Clarification. 4

(Date of issue of Clarification No 4: 01 September 2023)

Contract No. and Title: KUKL/WW/TP/R-02: Construction of Remaining works of Wastewater Treatment Plants at Sallaghari, Kodku and Dhobighat

GENERAL LAYOUT PLAN OF STONE COLUMN FOR DHOBI GHAT

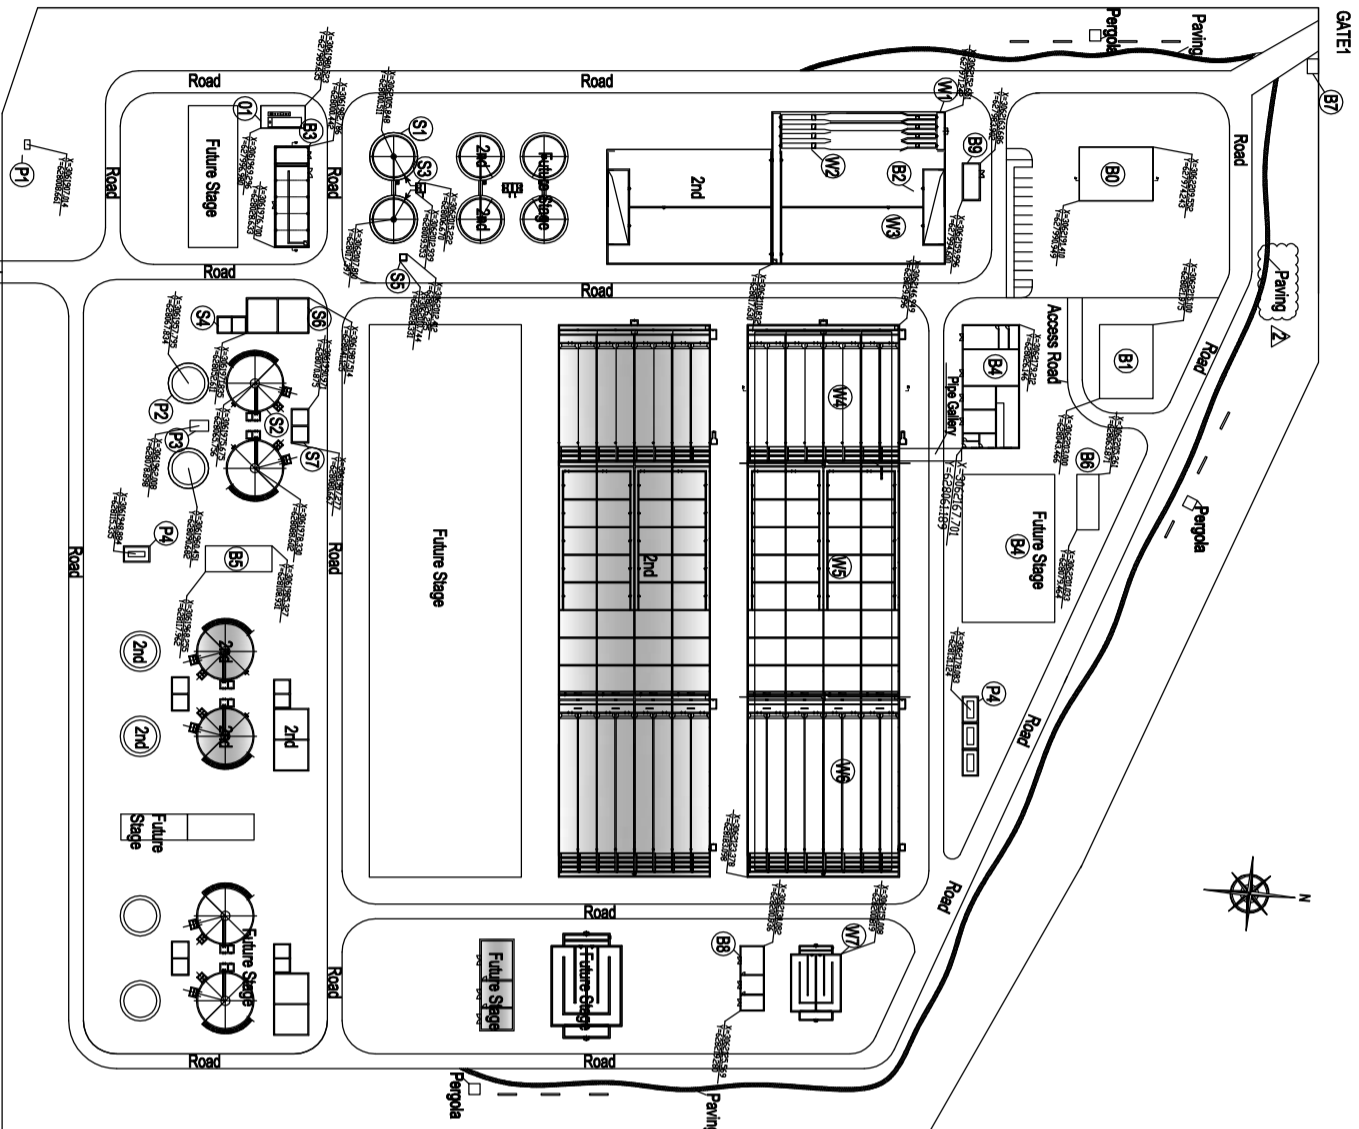
24.		We couldn't find much more information and details about the stone column works from section 6A & 6B and attached drawings as it said some works are not completed. Please kindly provide the design drawings about stone column to help us review the remaining works.	Please refer Clarification No. 2- Response to Query Number 305 to 315 and Section 6-Employer's Requirement -Appendix 6 A-1 and 6B. the details will be provided to the successful bidder. Please refer the stone column details in the website: https://kuklpid.org.np/
